# CITY OF ALBUQUERQUE

RE: **Heritage Marketplace Tract C3**  
**1720 Unser Blvd**  
**Conceptual Grading and Drainage Plan**  
**Engineer's Stamp Date 6/26/17 (File: H09D027)**

Based on the information provided in your submittal received 6/27/17, the Grading and Drainage Plan is approved for Site Plan for Building Permit.

PROJECT TITLE HERITAGE MARKET PLACE - TRACT C-3 1720 UNSER BLVD NW ALBUQUERQUE, NEW MEXICO 87120	DRAWN BY: JEFF WOOTEN
PROJECT MANAGER JEFF WOOTEN	JOB NO. 2016029
SHEET TITLE Grading Plan	SHEET NO. 2

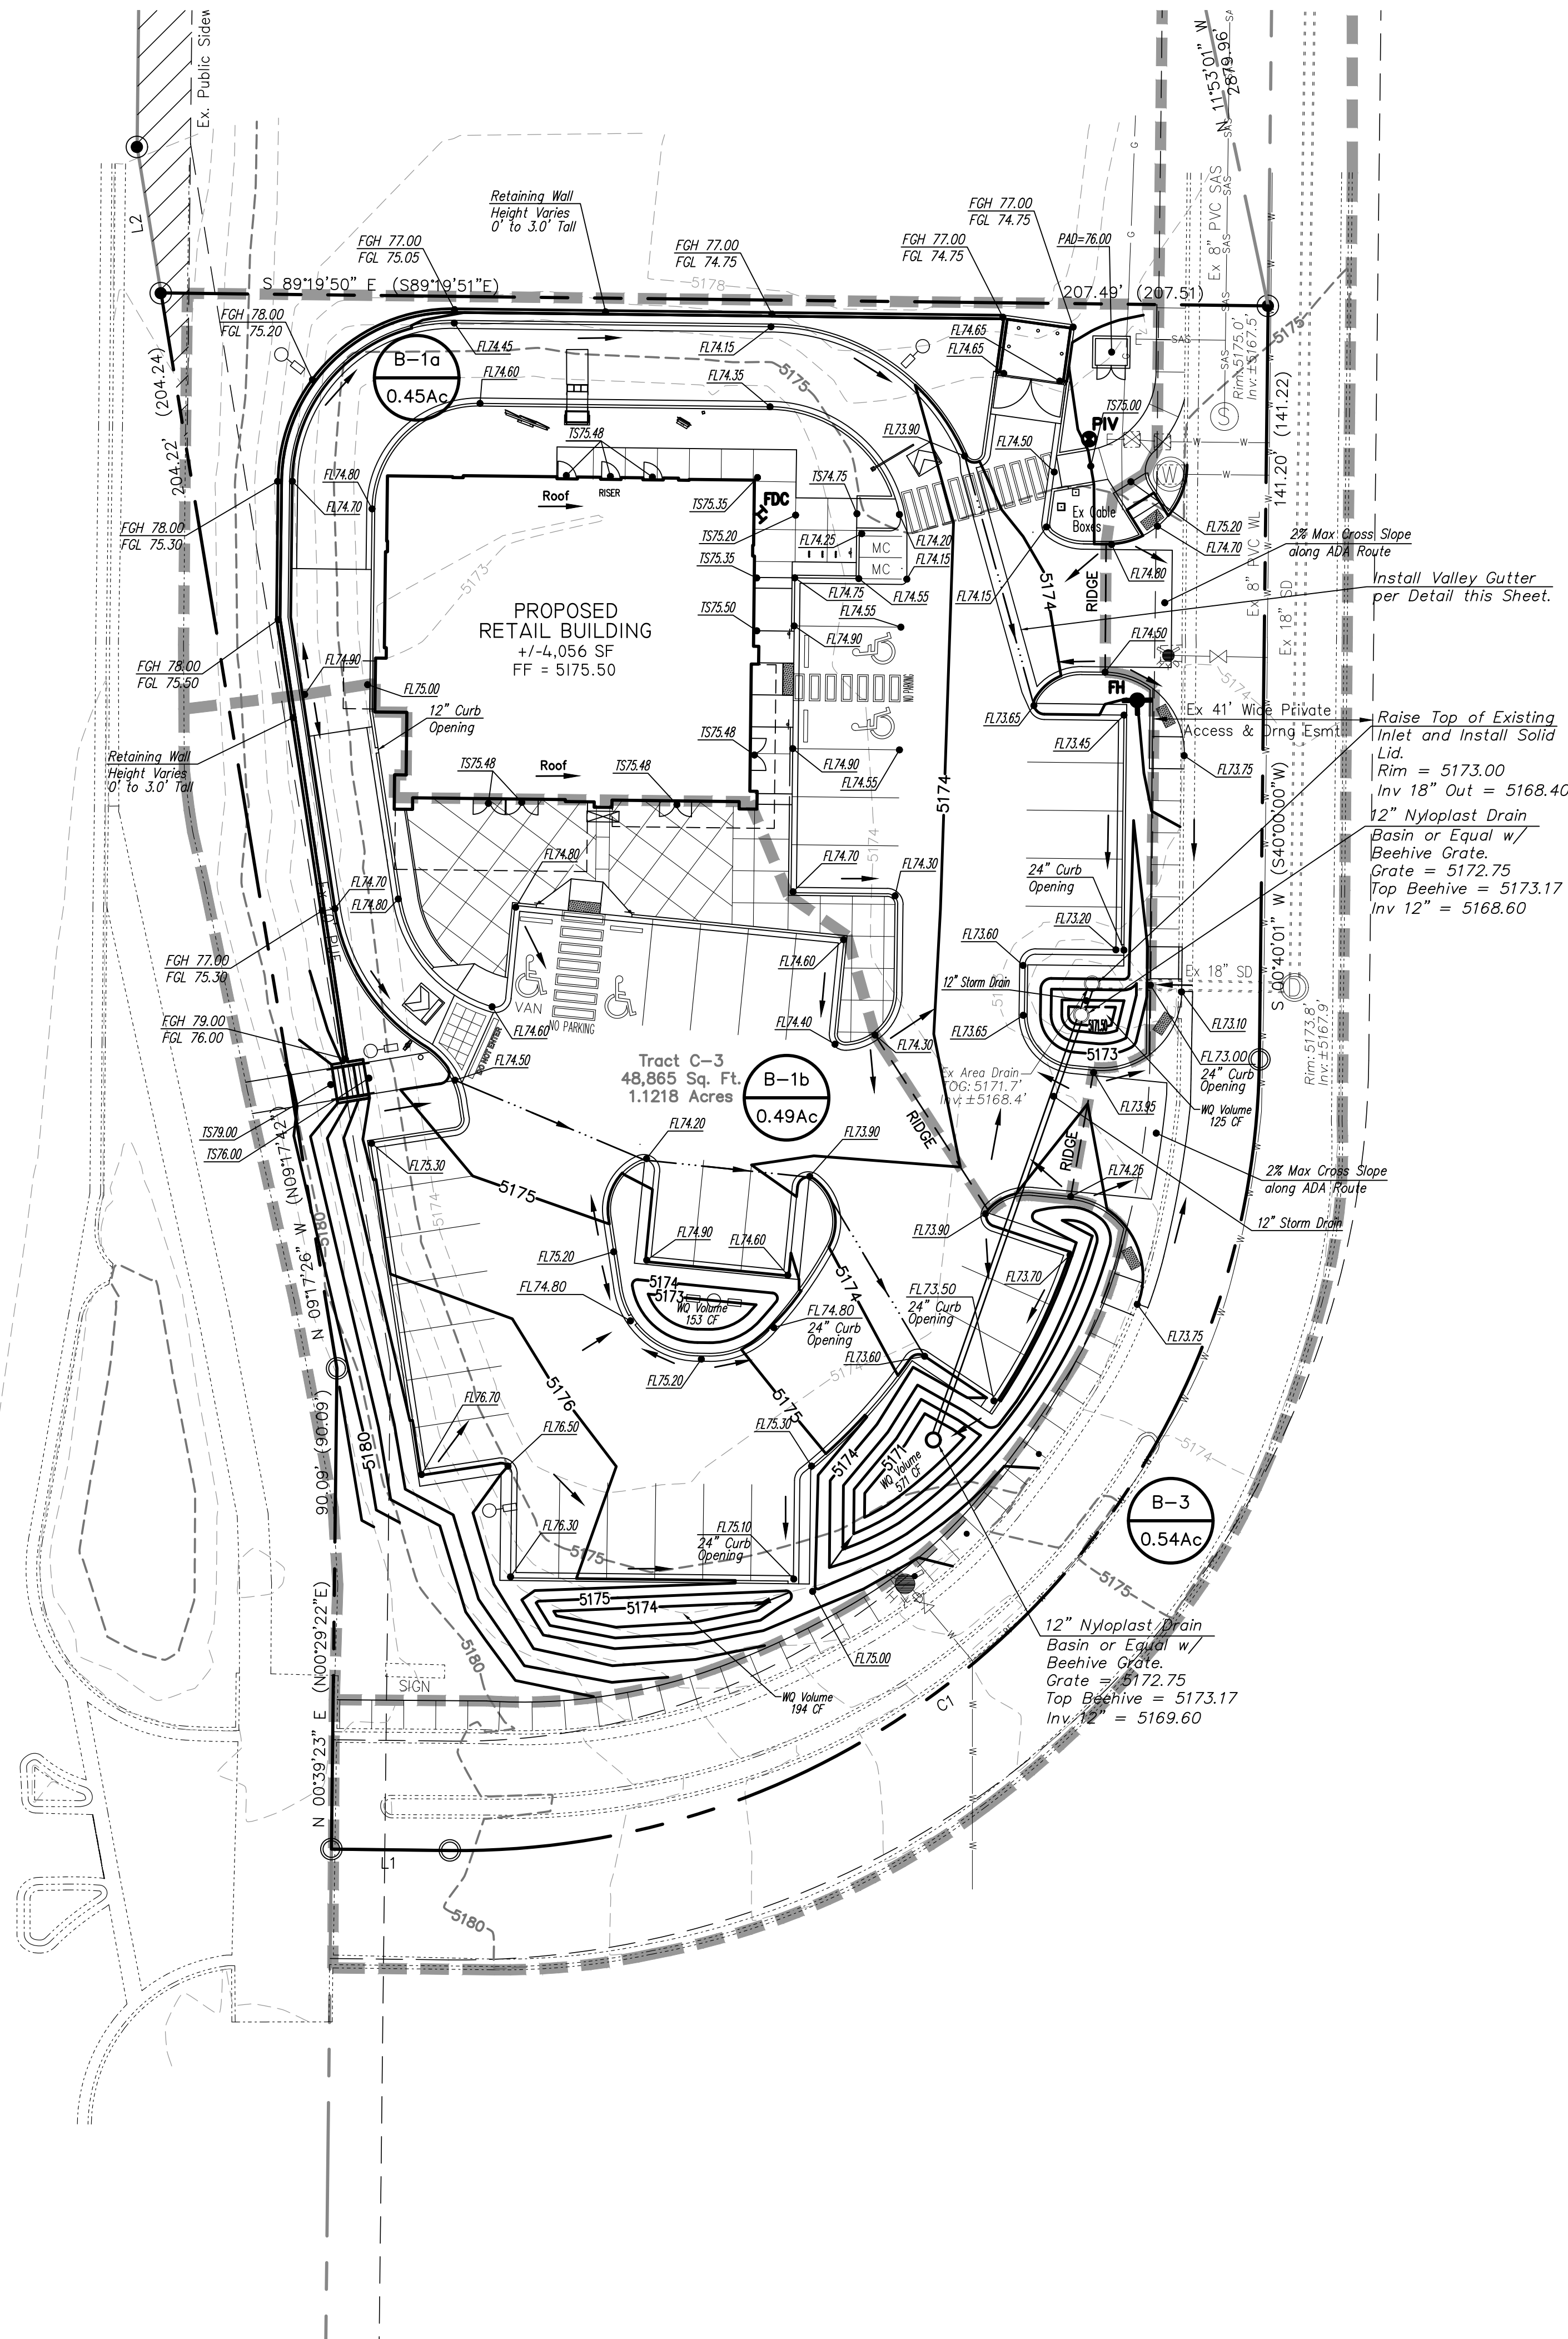
1. This work requires an Erosion and Sediment Control Plan to be submitted to the storm water quality engineer (Curtis Cherne, PE, [ccherne@cabq.gov](mailto:ccherne@cabq.gov)).
2. A private facility drainage covenant is required on the ponds.
3. According to the Heritage Marketplace Drainage Report, the entire development is allowed 2.4cfs/ac. However tract C-3 (referred to as Basin B-1 in the Drainage Report) is only allowed 2.1cfs in total. Other areas, such as roads are allowed to discharge greater amounts. Detention times and pond sizes will need to be increased to account for this.
4. The dumpster areas must be contained plumbed through a grease trap, and into the sanitary sewer. Include the utility plan if this information is located there.
